Product Change Notification

Product Change Notification: P-17-014218

2mm HM connector

CSA mark

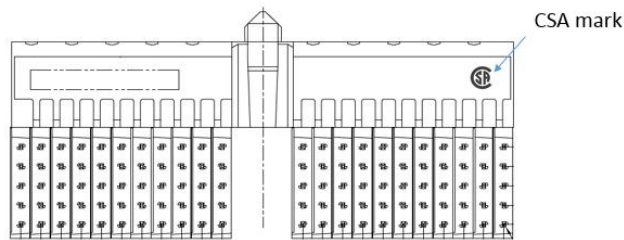
The products will be add a CSA mark on plastic.

Product improvement. 2mm HM connectors had passed CSA (Canadian Standards Association) certification since 1996, but CSA mark was not added on product. CSA request to add CSA mark on each connector.
